29 March 2021

**INFORMAL REFERRAL COMMENTS – DA 090/M023/21
126 ROSE TERRACE WAYVILLE**

Construction of an eight (8) storey mixed use building comprising residential apartments, café, ancillary car parking, landscaping, and associated building work.

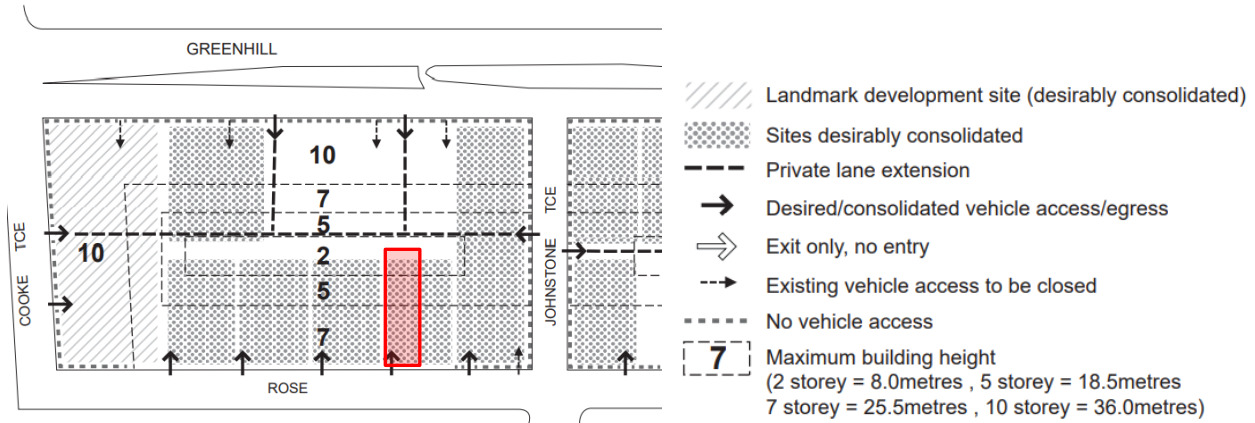
- Development involves a mixed-use building comprising café of 84m² (60m² indoor and 24m² outdoor) and associated foyer and service rooms on ground level and 25 apartments above (18 x 2 bedroom, 6 x 3 bedroom and 1 x 4 bedroom). Limited diversity of dwelling sizes, but a net density of over 260 dwellings per hectare, well above desired minimum of 75 d/Ha;
- Development does not include the 15% of 'Affordable' dwellings;
- Height to eight (8) storeys (28.5 metres) versus policy of seven (7) storeys (25.5 metres). Represents a notable but not large variation over the total desired

height by 3.0 metres (12%) and building has a recessed top level and lightweight roofing edge;

Concept Plan Un/7

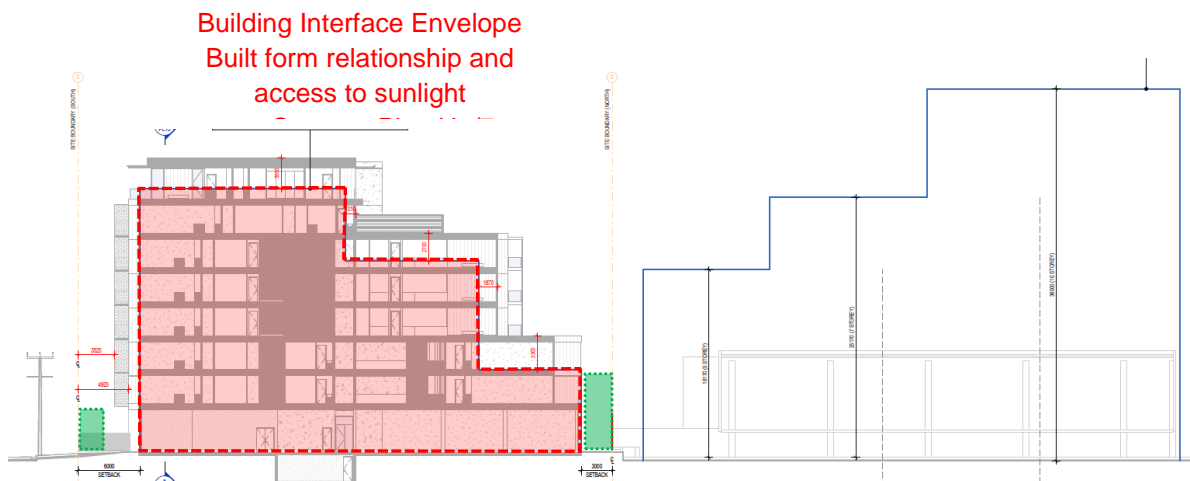
- The Building Interface Envelope is derived from Concept Plan Un/7 provides for proper and orderly development and appropriate urban design outcomes;

- Unfortunately, with such an attempt at large-scale development of a small individual site an inherent tension arises that compromises the primary policy principles for a larger consolidated site, proper boundary setbacks, landscaped setting and overall better and more efficient development outcome;
- The Building Interface Envelope aims to afford an appropriate relationship and juxtaposition between the respective high-rise built-forms along Greenhill Road and Rose Terrace and a reasonable mutual access to sunlight;

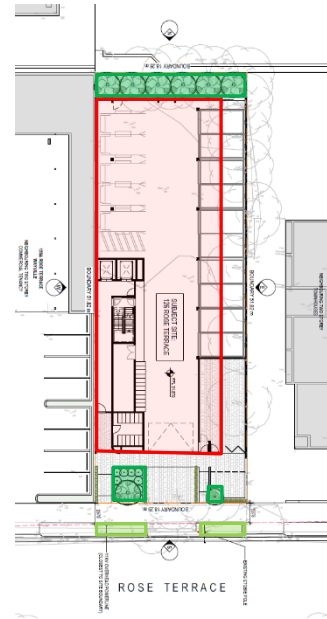
- At the ground level Rose Terrace setback 5.9 metres (versus 6.0 metres) but space encroached in effect by extending building side walls and solid side enclosures to balconies above to seven storeys of 4.9 metres, noting open balconies extending to 3.5 metres, compromising front setback relief to street;

- At the ground level 0.0m setback to side boundaries does not address required 3.0m side street to one boundary, lacking relief to neighbour from long and plain building façade, and increasing building foot print to 82% compared to desired policy of 70%. Acknowledge setback provided above ground level, for residential amenity and building articulation;
